Subject: Diversion Works for Permit 65-13912
Carol MacGregor – Belvidere Hot Springs

Re: MacGregor Residence

Per your request, here is my evaluation and review comments on the HVAC heating system at the MacGregor Residence corresponding to Diversion Works Permit # 65-13912 - Conditions No. 8 and #65-13913 - Condition #7. Specifically, I have concentrated on the use and effectiveness of the geothermal hot water system and how it is utilized by the HVAC system.

DRAWING BY: AUGUST K. POND.

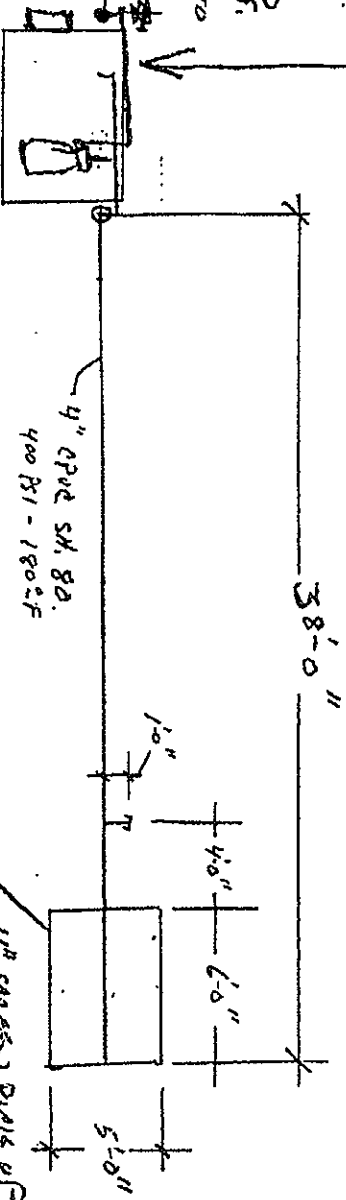
The diversion works for 65-1972 and 65-1973 consist of a gallery of perforated pipes that were placed in the lower hot pool at the spring, a suction pump, and piping to a home. Prior to installation of the pipes, the hot pool was cleaned of debris using a backhoe. The gallery pipes were then installed approximately 3 feet below grade in a 6-foot by 5-foot rectangle. Above the gallery pipes is a bed of 1.5-inch drain rock that is covered by geotextile membrane. The membrane is covered with washed ballast rock. The gallery pipes are 4-inch CPVC with horizontal slots. A non-perforated 4-inch pipe extends approximately 30 feet from the gallery to the pump. A 2-inch insulated CPVC pipe extends approximately 900 feet southwest from the pump to a home with a soaking pool. A 4-inch ABS pipe returns the water to Moores Creek. An as-built schematic of

the diversion works and photographs of construction provided by the contractor, Gilbert Pond, are attached.

The discharge from the pump has a threaded attachment point that could be used to connect additional pipe. In the event that water rights 65-12891 and 65-13332 are adversely diminished by diversions under 65-13912, piping could be connected at this location and extended less than 200 feet to supply the source of 65-12891 and 65-13332. In an emergency, such a connection could be implemented in a few hours if needed.

Flow rate through the system can be measured using a bucket and stop watch at the return point to the creek. If needed, the pump can be locked out at the disconnect switch.

GEOHERMAL WATER PIPING SCHEMATIC (WELL SIDE) NTS

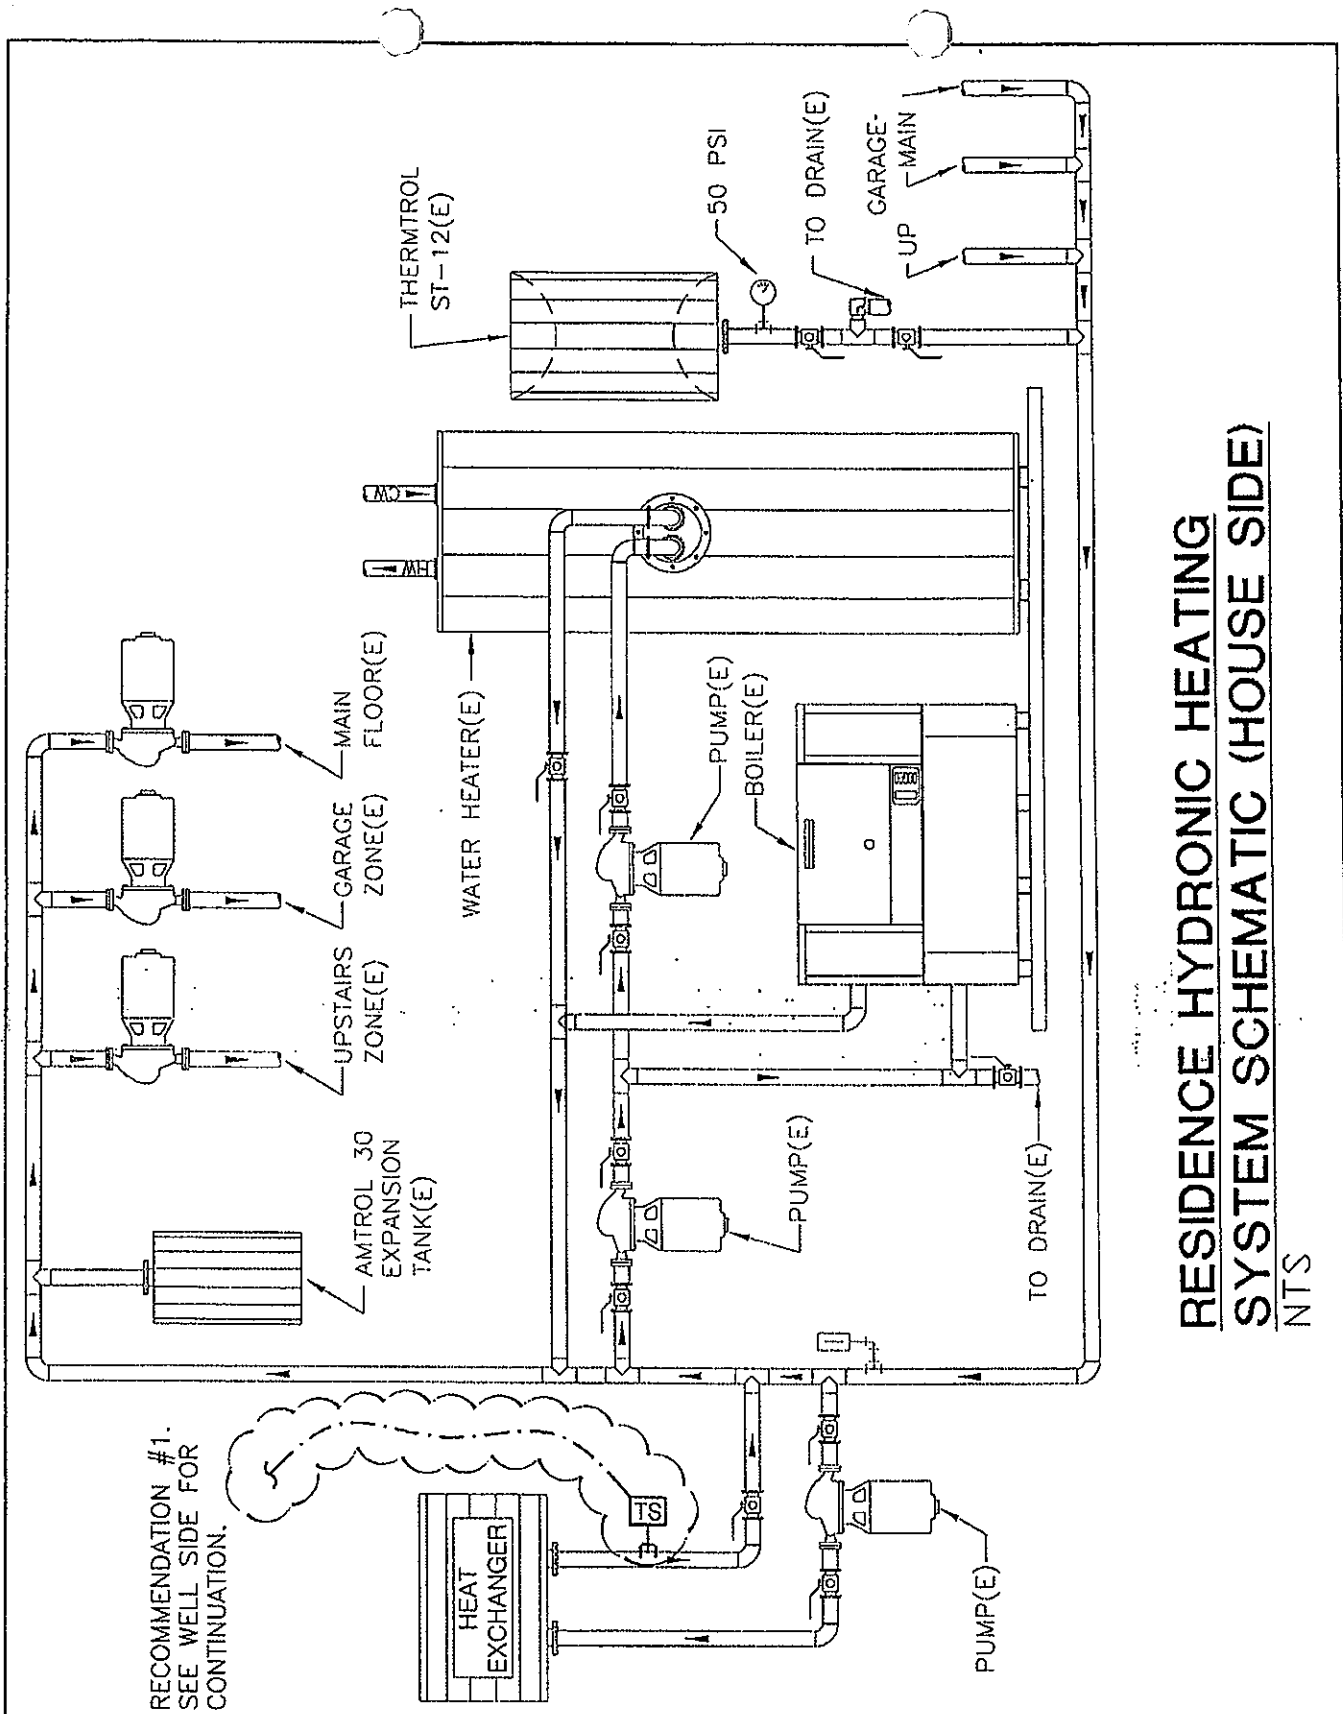
#1 Use a "demand controlled" system for the pumping of the geothermal water.

Typical geothermal systems are charged based upon their consumptive use of the geothermal water, and therefore typical system utilize a "demand controlled" system for controlling the amount of flow through the heat exchanger. This type of system is typically controlled by a thermostat on the "house" side of the heat exchanger and when the "house side" of the heat exchanger is satisfied, a control valve on the "well side" will close and eliminate the flow of geothermal water through the heat exchanger.

In the "well side" piping system there is typically a pressure sensor that reacts to this control valve and signals the well pump "vfd" to reduce pump flow or even turn off the pump in times of "no heating demand".

This is a very common design feature in hydronic systems and one that should be considered in this system to reduce overall geothermal water flow and consumption.
